Re: FCC ID LKTEAP-10AMP
Applicant: BreezeCom, Ltd.
Correspondence Reference Number: 7618
731 Confirmation Number: EA93721

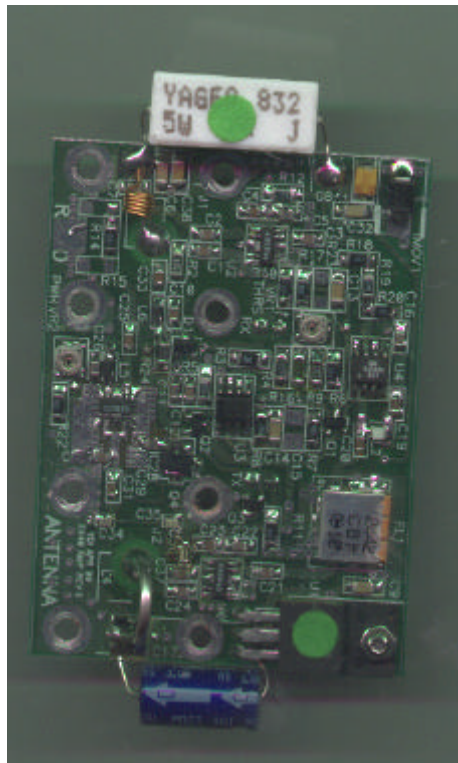
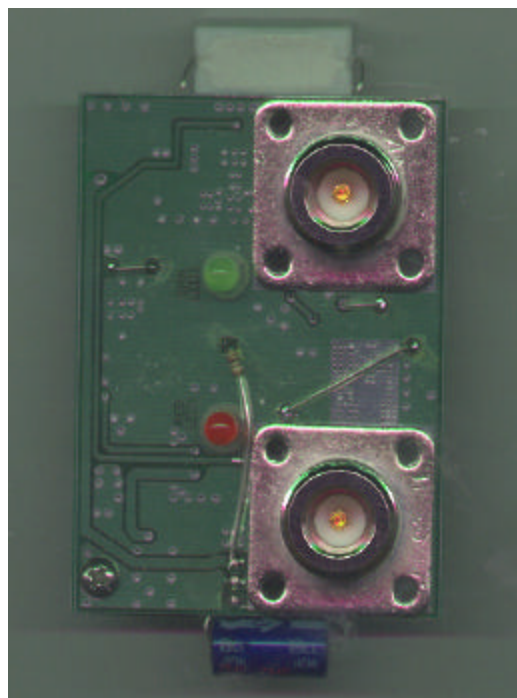
The manufacturer relaid the amplifier PCB so that the external filter would not be necessary. The amp/transceiver and antenna combinations were rechecked for compliance with the commissions rules. The results are very similar in most cases. A few of the harmonic levels improved. The schematics remain the same. I have include new photos of both the component and solder sides of the amp. A new layout incorporates a low pass filter using true inductance and dielectric capacitance in the board to provide the filtering. No other components were added. For any further information, please contact me.
